7311 Baltimore Avenue Takoma Park  
~~MD~~ 2nd Preliminary Consultation  
Takoma Park Historic District

*2<sup>nd</sup> Preliminary Consultation*  
**MONTGOMERY COUNTY HISTORIC PRESERVATION COMMISSION**  
**STAFF REPORT**

<b>Address:</b>	7311 Baltimore Avenue, Takoma Park	<b>Meeting Date:</b>	7/28/2010
<b>Resource:</b>	Contributing Resource <b>Takoma Park Historic District</b>	<b>Report Date:</b>	7/21/2010
<b>Applicant:</b>	Mark Freedman and Kristen Summers (Amy Abrams, Agent)	<b>Public Notice:</b>	7/14/2010
<b>Review:</b>	2 <sup>nd</sup> Preliminary Consultation	<b>Tax Credit:</b>	N/A
<b>Case Number:</b>	N/A	<b>Staff:</b>	Josh Silver
<b>PROPOSAL:</b>	Rear addition

1st Preliminary Consultation  
Proposed Roof Plan

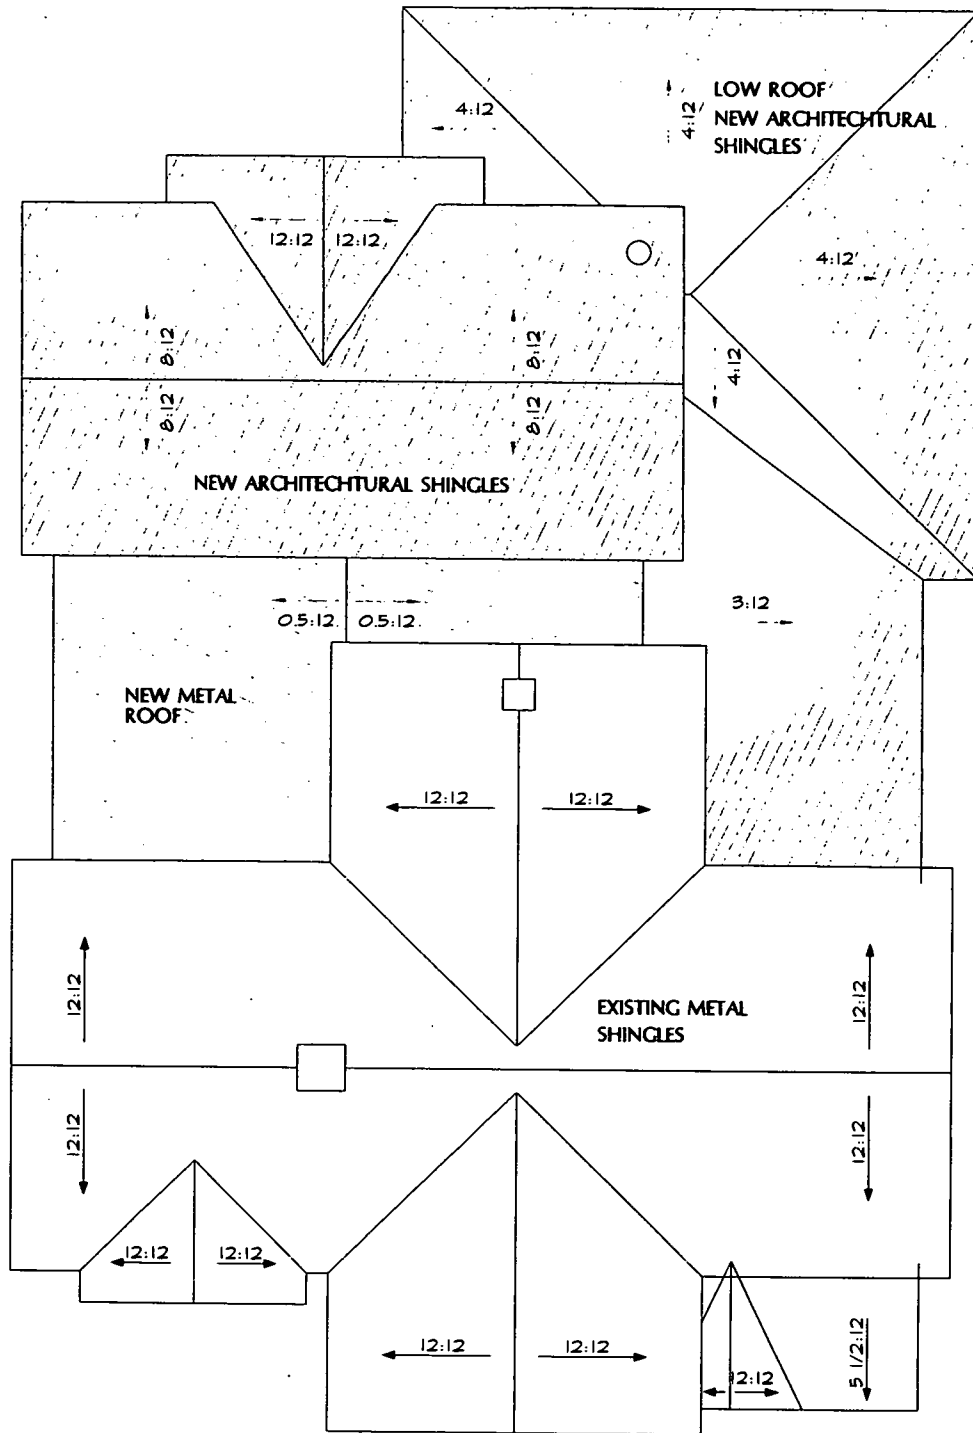
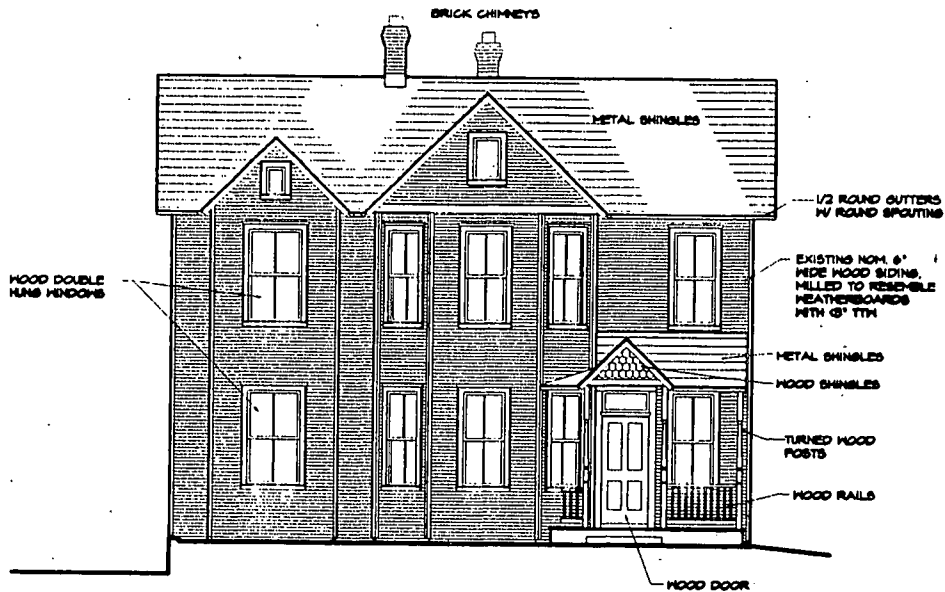
3. The use of a modified barrel roof form is inappropriate for this resource. A sloped/pitched roof form was recommended to simplify the design and transitions between the different roof masses

PROPOSED LEFT ELEVATION  
1/2" = 3/16" = 1'0"

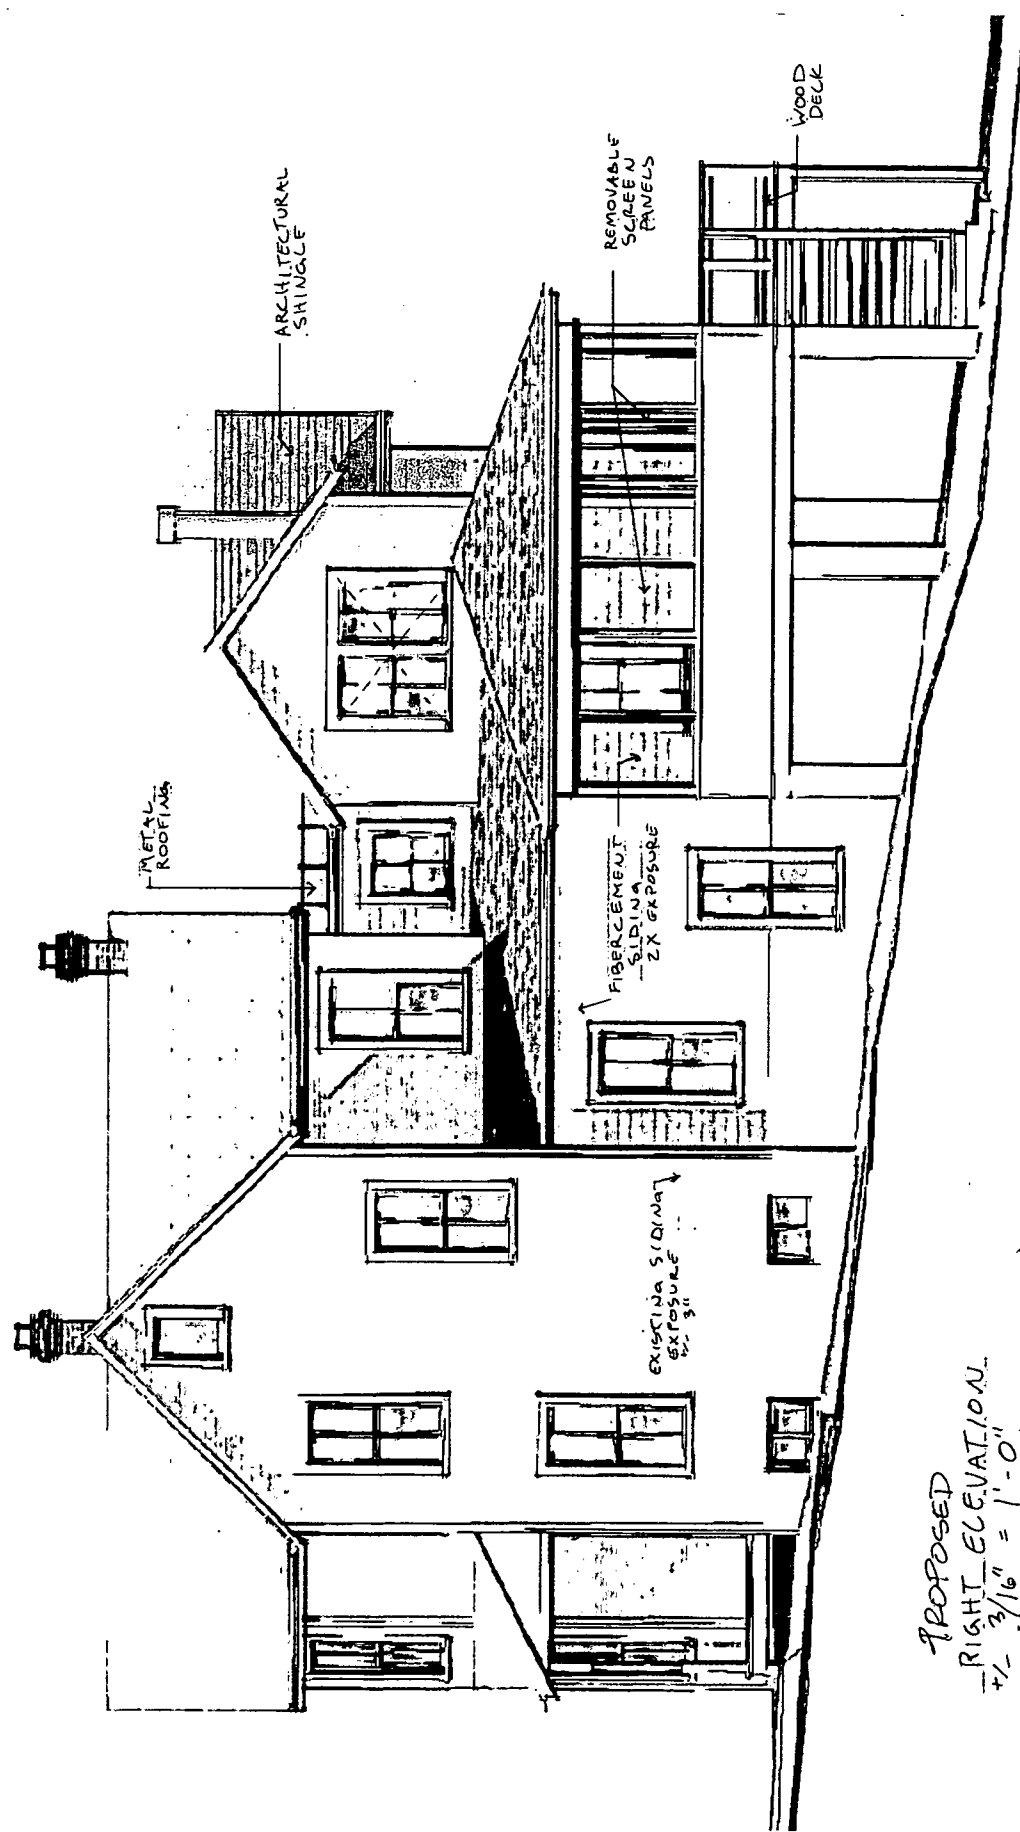
Staff recommends eliminating the proposed 2 story cantilevered bay on the rear elevation. Removal of this feature would assist with reducing the perceived scale of the addition and simplify the transitions between the different roof forms. A shed roof form consistent with the roof pitch for the proposed 1 story addition on the right side elevation should be used for the proposed screen porch roof in lieu of a hipped roof. A shed roof form would maintain a consistent roof profile throughout the length of the 1<sup>st</sup> story addition and better integrate the porch with the addition.

1st Preliminary Consultation  
Proposed Southwest (Side) Elevation

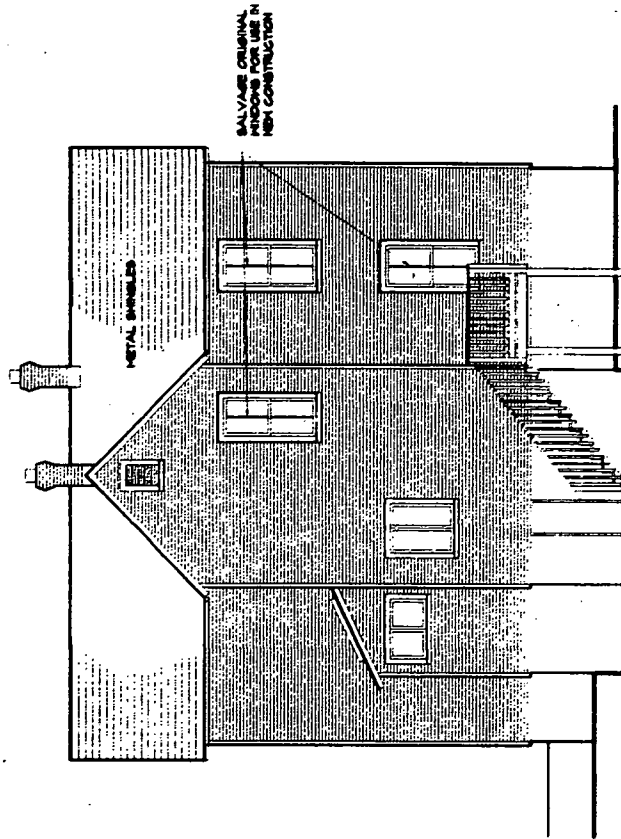
7. The size and orientation of the porch should be reduced and better integrated with the rear addition to help mitigate the overall scale of the addition and horizontality of the feature
